AREA 1 FIELD SAMPLING PLAN
ADDENDUM TO REMEDIAL INVESTIGATION
WORK PLAN
FOR PER- AND POLYFLUOROALKYL SUBSTANCES
(PFAS)

FORMER FORT DEVENS ARMY INSTALLATION, DEVENS, MA

SEPTEMBER 2018

**U.S. ARMY RESPONSES TO U.S. EPA COMMENTS ON THE
DRAFT AREA 1 FIELD SAMPLING PLAN ADDENDUM TO
REMEDIAL INVESTIGATION WORK PLAN FOR PFAS
Former Fort Devens Army Installation, Devens, Massachusetts
8 August 2018**

Figure
5

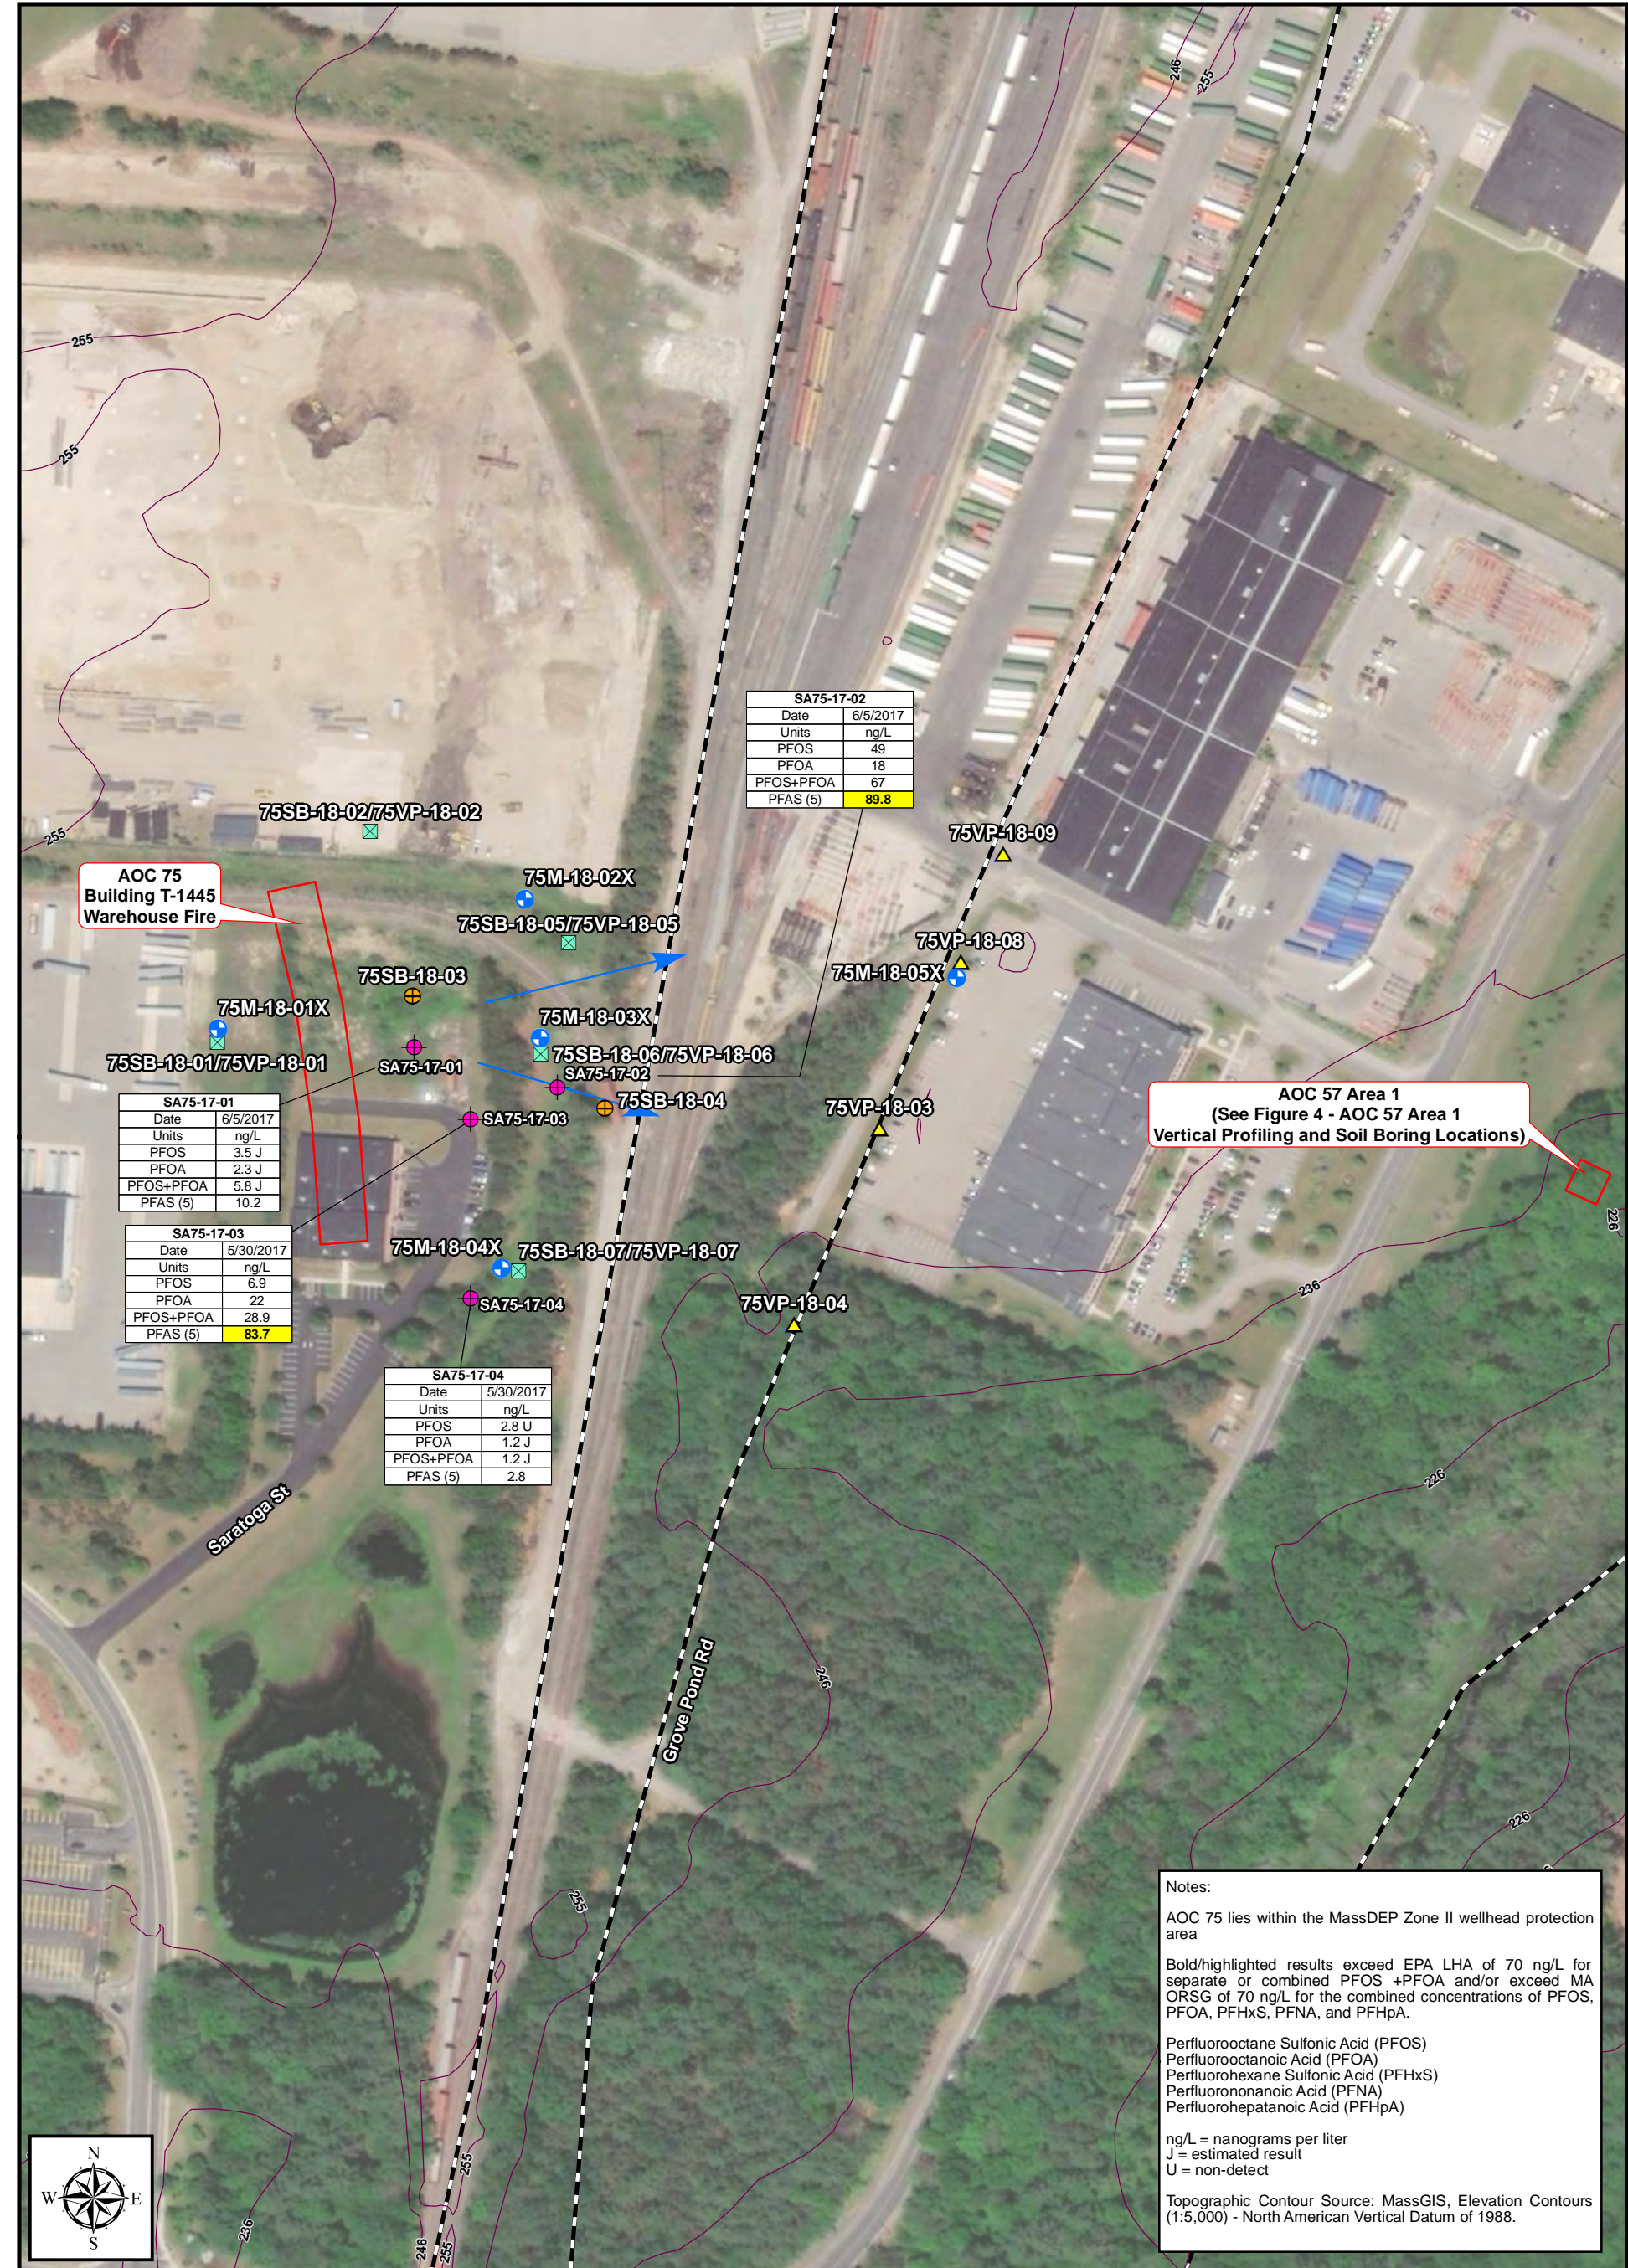
Comment #5: Figure 5: Surface water and sediment samples CSB-18-06 and CSB-18-07 should be collected from locations most likely to be impacted by PFAS released from AOC 74 as determined by proximity to source area, surface and groundwater flowpaths, and long-term monitoring surface water sample results. The conditions used to determine the sampling locations should be documented in the RI report.
